Model: SA-7S1, SA11S1, SA-15S1, SA8001

Subject: Software Update Information (on improving the playability of the RoHs-compliant pickup)

RoHs compliant pickup

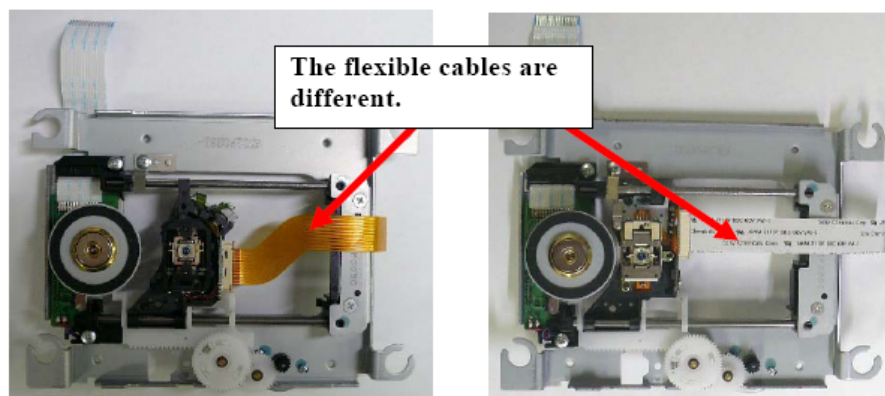
Details: 1. When servicing units with RoHs-compliant pickups, please update the software. Also, please do so when noncompliant pickups are replaced with compliant ones.
2. Some units need a resistor replaced as well as the update. Refer to the serial numbers below and replace their resistor R502 with 100 ohm as well as updating the software.

Solution: When servicing units with RoHs-compliant pickups (see below) or replace noncompliant pickups with compliant ones, please update the software.

Replacing R502

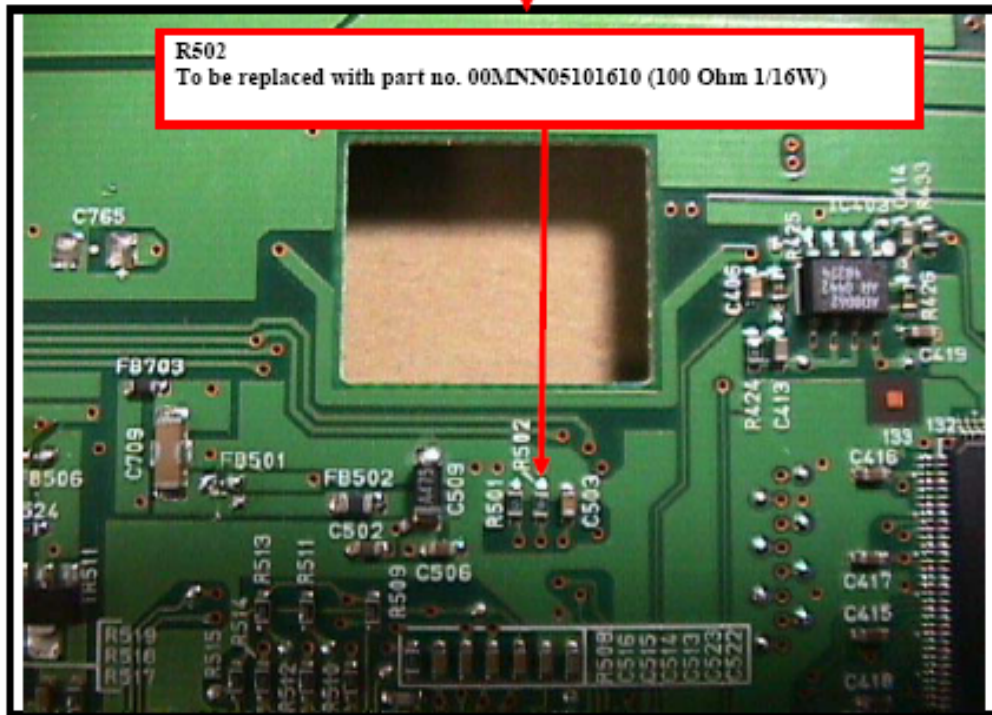
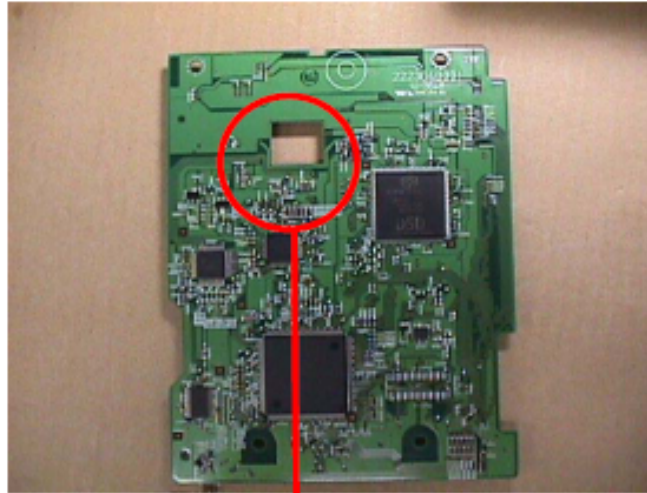
Some units may need a resistor replaced as well as updating. When updating the software of units with the following serial numbers, please replace their R502 with a 100 Ohm.

Serial number range: 20000727000051 ~ 080

Ref#	Description	Part Number
NA	Update disc	90M-SA0001DVD
R502	100 Ohm	00MNN05101610
